Re: Turkey Point Units 3 and 4  
Docket Nos. 50-250 and 50-251  
Response to NRC Request for Additional Information Regarding  
Extended Power Uprate License Amendment Request No. 205 and  
Safety Analyses Issues – Round 1

**Turkey Point Units 3 and 4**

**RESPONSE TO NRC RAI REGARDING EPU LAR NO. 205  
AND SRXB SAFETY ANALYSES ISSUES – ROUND 1**

Figure 1: RCS and Secondary Pressures (EPU)

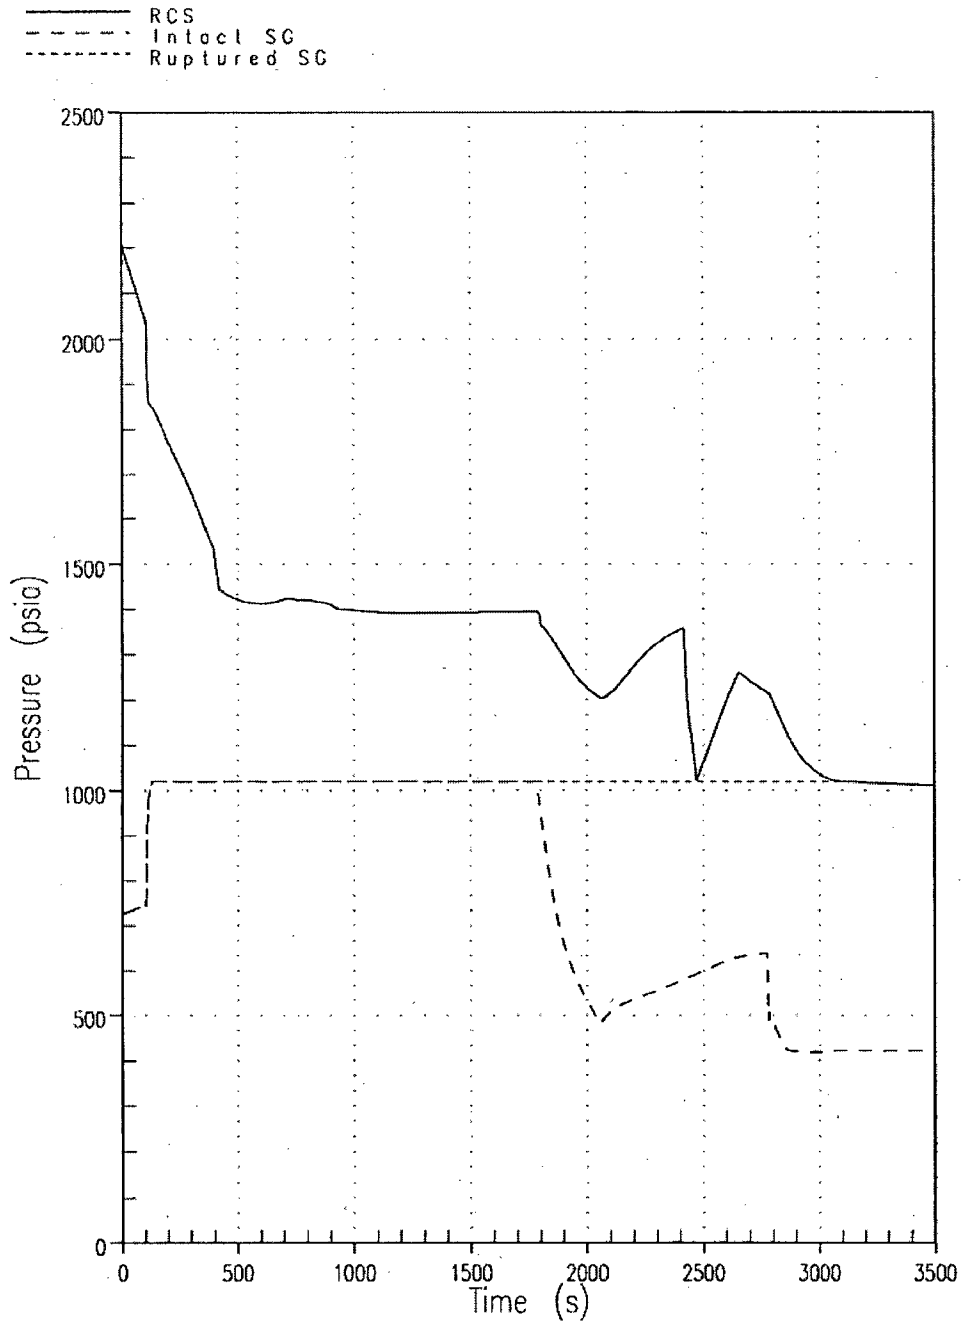
**SRXB-1.1: Provide a thermal hydraulic analysis for Turkey Point at the proposed, uprated conditions, for a limiting margin-to-overfill/overfill scenario. One acceptable methodology would be for the analysis to align as closely as possible to what is approved in WCAP-10698-P-A; however, since the licensee has asserted that a limiting single failure is not in the Turkey Point licensing basis, this exception to the WCAP-10698-P-A methodology would be acceptable. Consider limiting single failures and discuss what they could be.**

The results indicate a margin to overfill greater than 300 ft<sup>3</sup> in the ruptured steam generator (SG) for the EPU case. No water is transferred into the steam lines. The sequence of events for the revised analysis is provided in Table 1. Figures 1, 2, and 3 provide the time-dependent primary and secondary pressures, primary-to-secondary break flow, and ruptured steam generator water volume, respectively, for the limiting EPU scenario.

Figure 4: Turkey Point Units 3 and 4 Vessel Noding Diagram for the Nine Downcomer Channel Stack Model

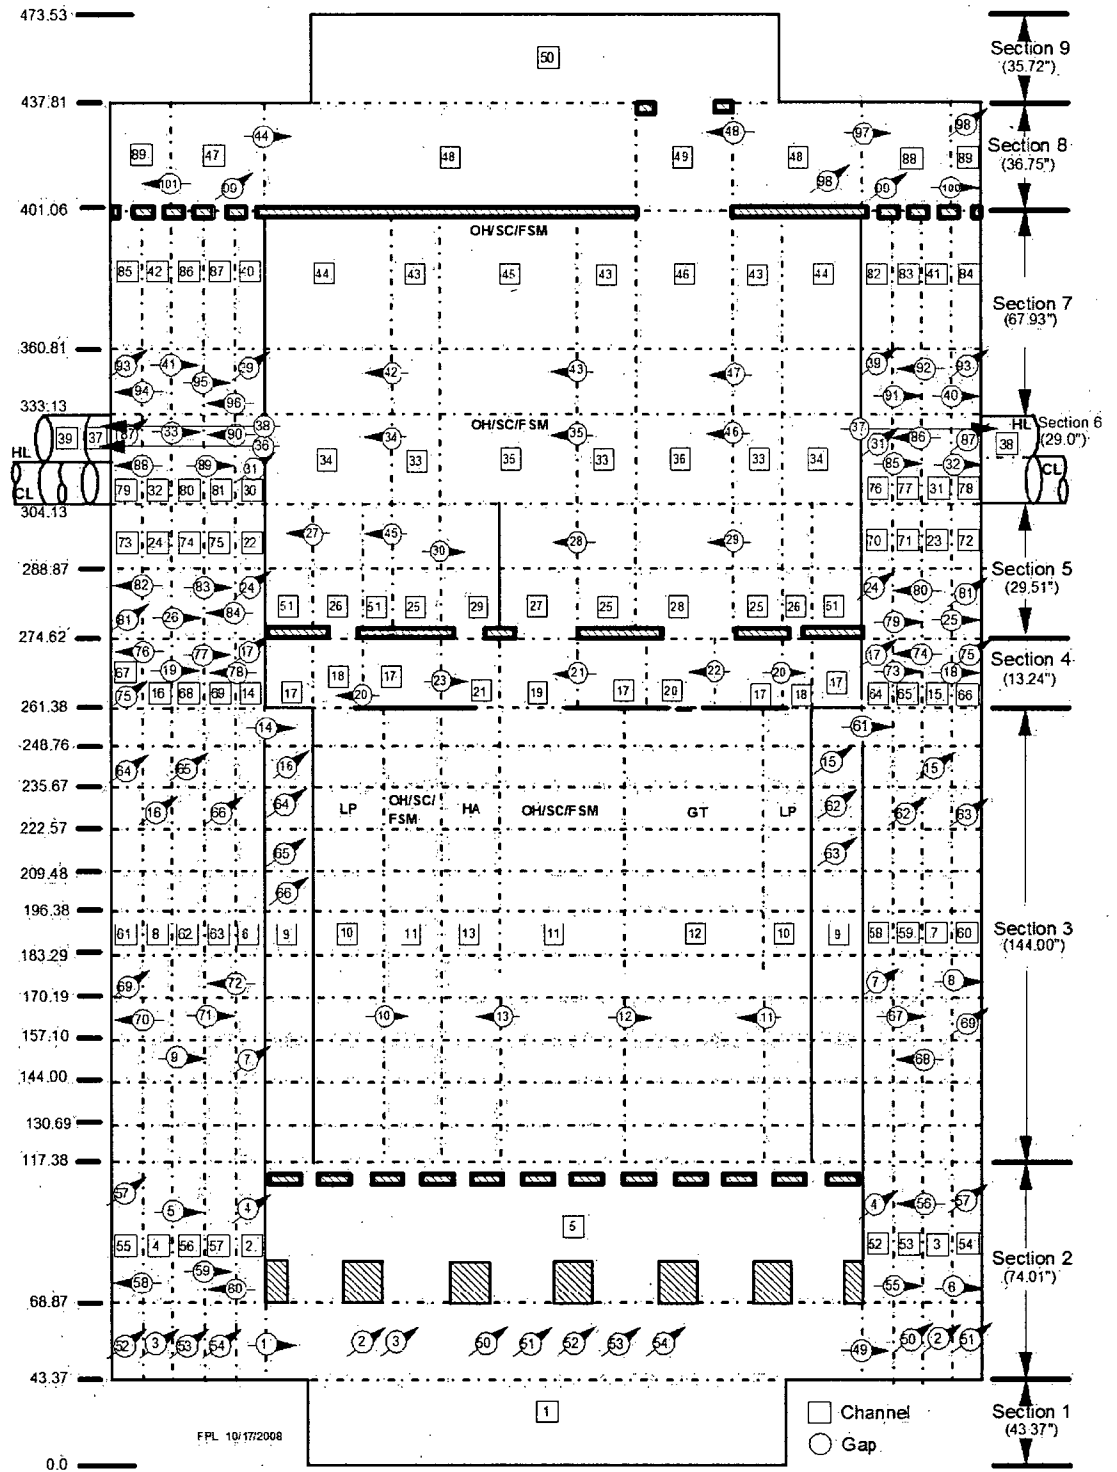
- a. Provide a detailed description and diagram of the downcomer nodalization, including both fluid and heat structures.**
- b. Identify the sources of heat modeled in the downcomer.**

The noding diagram for Turkey Point Units 3 and 4 with nine downcomer channel stacks is presented as Figure 4. The numbers enclosed in squares represent channel numbers. Channels are used to make vertical connections in the vessel model. The numbers enclosed in circles represent gap numbers. Gaps are used to make lateral connections in the vessel model. The gap numbers which have a horizontal arrow through them connect the channels shown at the start and end of the horizontal arrow. The gaps which have a diagonal arrow through them have a corresponding numbered gap shown elsewhere on the noding diagram. These gaps connect the channels with the matching gap numbers shown.

The downcomer channels are modeled with the long channel stacks shown on the outer portion of the noding diagram (Figure 4).
